# CITY PLANNING COMMISSION

- APPLICATION:
1. Special Permit to remodel an existing two-unit apartment complex into four units in the General Commercial (C-2) zone (Sec. 2-B-1 and 2-E-5)
  2. Variance to reduce the required minimum planter width from four feet to 2.5 feet (Sec. 6-D-5)

LOCATION: 2030 'H' Street

APPLC. NO. P84-102

EXHIBIT F

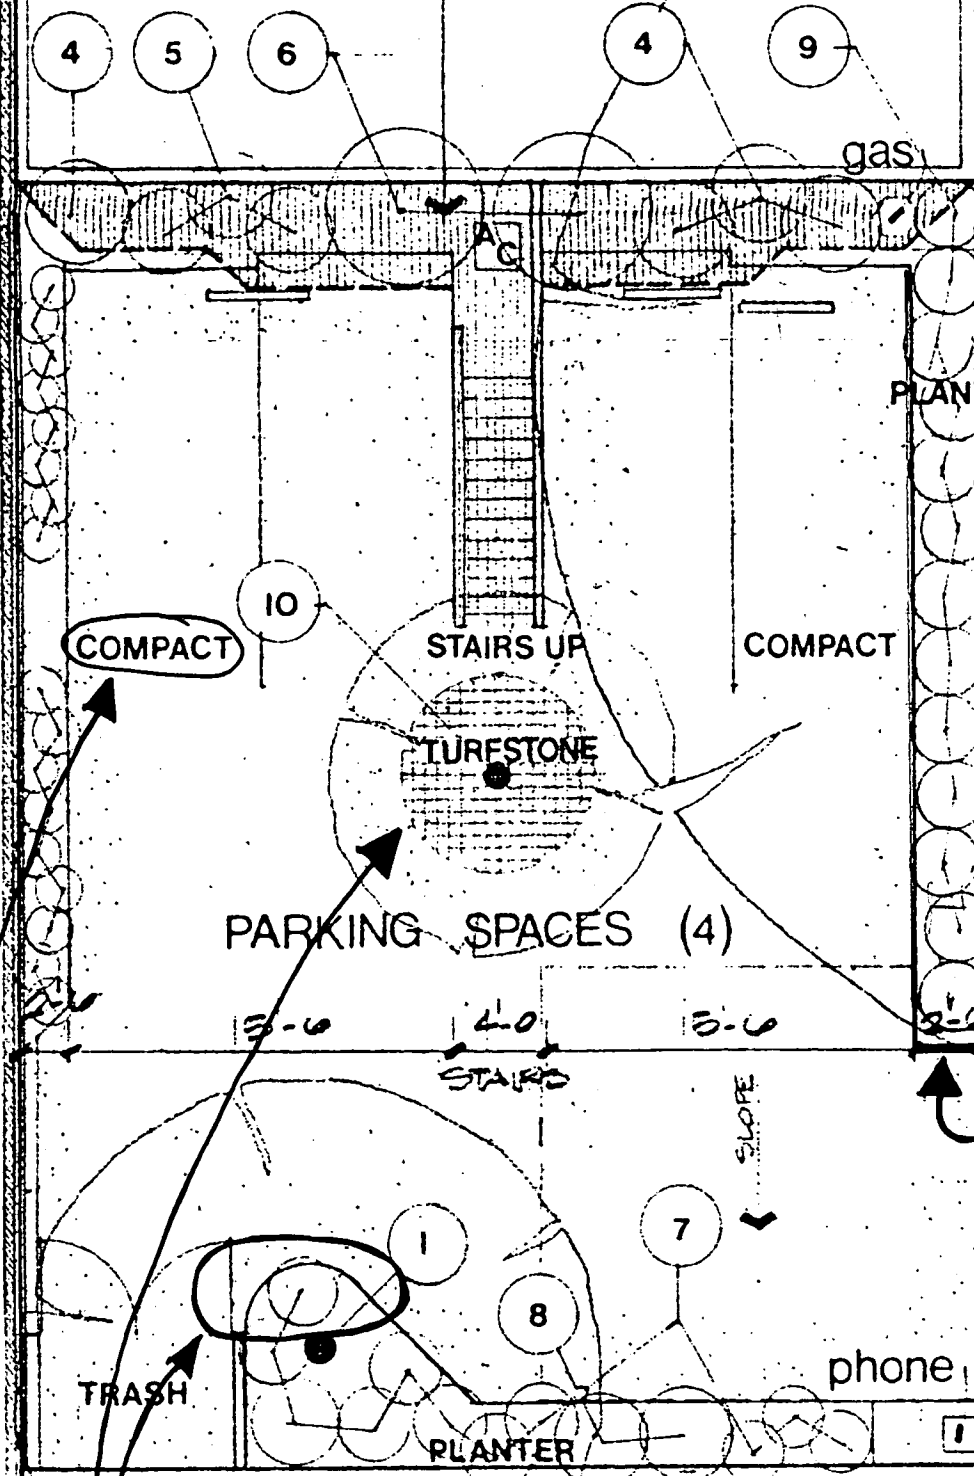
- a. Minimum required driveway width is 24 feet. Driveway must meet this requirement;
  - b. Proposed plum tree occupies required maneuvering space;
  - c. Car in western stall will have difficulty getting out of stall;

- d. Sidewalk planter is too narrow after curbing is installed around soil area;
  - e. Tight stalls against the narrow stairway seems rather hazardous.

6. Staff, however, has concerns regarding the design of the proposed parking area to the rear of the building. The applicant has designed the parking lot with a 2.5 foot wide planter on the street side and a 2.5 foot wide planter along the west property line (Exhibit F). The purpose of the planter along the west property line is to provide a dirt area to plant crawling vegetation on a lattice support that would eventually cover the bare wall of the adjacent building. The applicant proposes to create a 30-inch high formal boxwood hedge in the 2.5 foot street side planter (no curbing). The applicant believes that such planting would create a well landscaped courtyard and is requesting a variance to reduce the minimum planter width adjacent to 21st Street.

Variance requested by applicant to reduce width of this planter

Driveway does not meet minimum width requirements.

- \* Enough room for standard size stall and maneuvering area. Not a compact.
- \* Tree interferes with car maneuvering area. must be removed.
- \* Planter encroaches into required maneuvering width. Planter must be revised.  $\frac{1}{2}$  26' of

7. Planning staff agrees with the comments of the Traffic Engineering Division that the parking lot driveway should be widened to 24 feet to accommodate two-way traffic and that the plum tree proposed for the middle of the area be removed as it impedes effective automobile maneuvering. The planter along the south side of the parking area will also need to be revised so that it does not interfere with the required 26 feet of automobile maneuvering width. While the applicant is only required to provide two parking spaces for the two-unit residential expansion, a four-car parking lot is preferred as it will relieve parking congestion in the area and insure building residents a place to park. Staff recommends that a sign be placed at the driveway entrance noting that the parking lot is for the residential use only and not for the patrons of the commercial uses on the subject site.

- a. A revised parking lot design shall be submitted for staff review and approval prior to issuance of building permits. The revised design shall include the minimum required 24-foot wide driveway and four-foot wide planter and four automobile parking spaces;
- b. A sign shall be placed at the driveway entrance indicating that the parking lot is for residents only;
- c. A revised shading, landscape and irrigation plan shall be submitted for staff review and approval prior to issuance of building permits.

**EXHIBIT G**  
**Staff Revision**

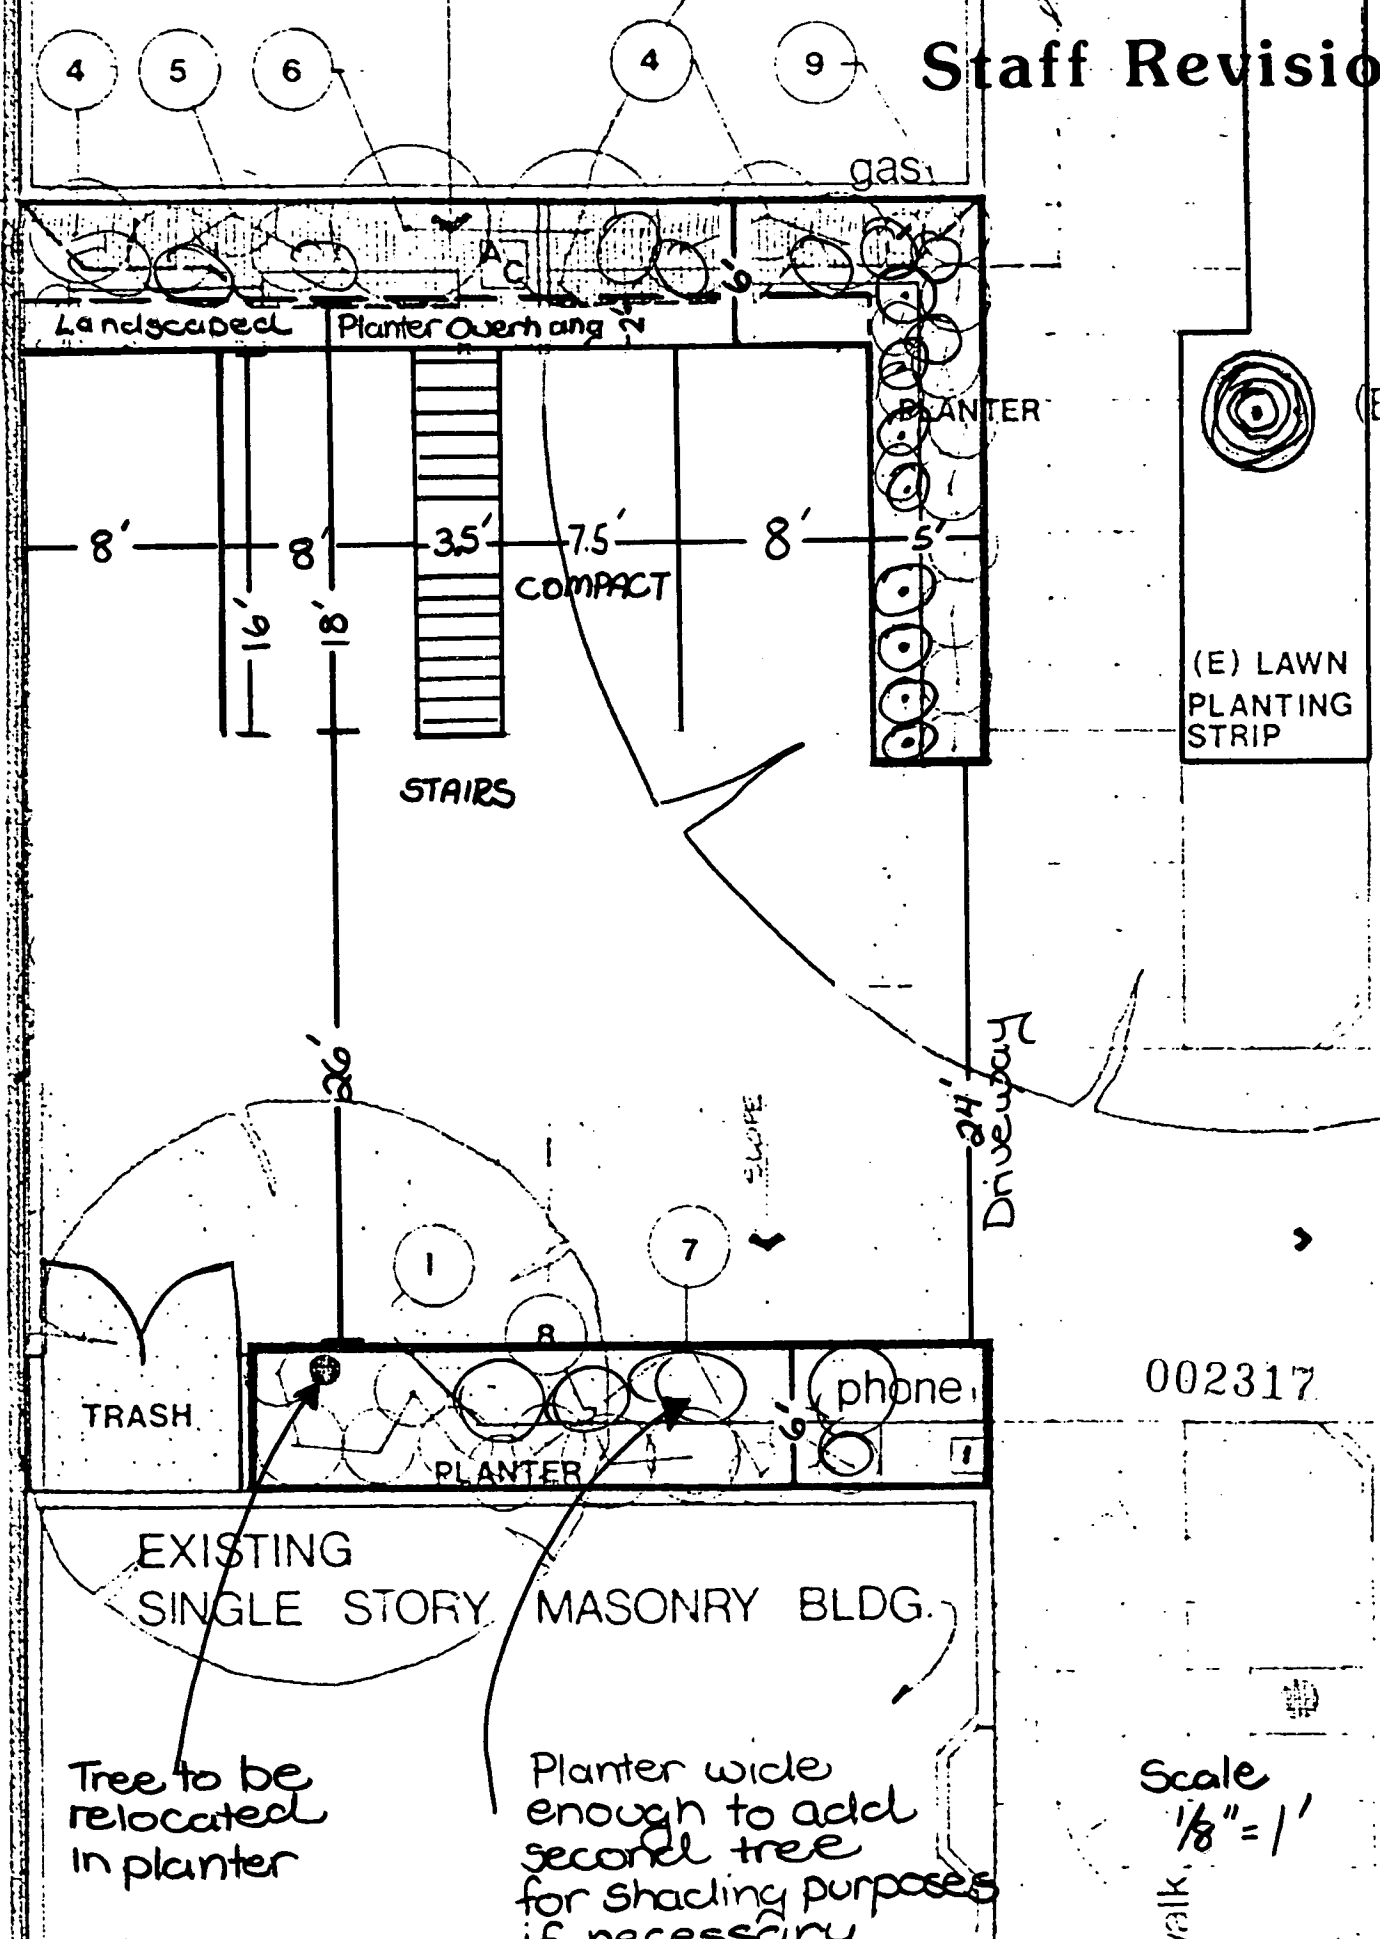
The parking area, however, can be designed to accommodate the minimum four foot wide planter and one foot of bumper curb required for parking areas along public streets (Exhibit G). The Zoning Ordinance requires a minimum of four feet of soil area for planters adjacent to public streets as this width is necessary to insure healthy and effective screening shrubs. The applicant's 2.5 foot wide planter design would jeopardize the health of the shrubs located in this street side planter. In addition, it is possible that the vegetation proposed by the applicant along the west property line would be damaged by cars maneuvering in and out of the adjacent parking space. The site would be better served by having the required planter width along the public street rather than splitting the planter area in two. Staff, therefore, recommends denial of the variance request.

Tree to be relocated  
in planter

Planter wide  
enough to add  
second tree  
for shading purposes  
if necessary
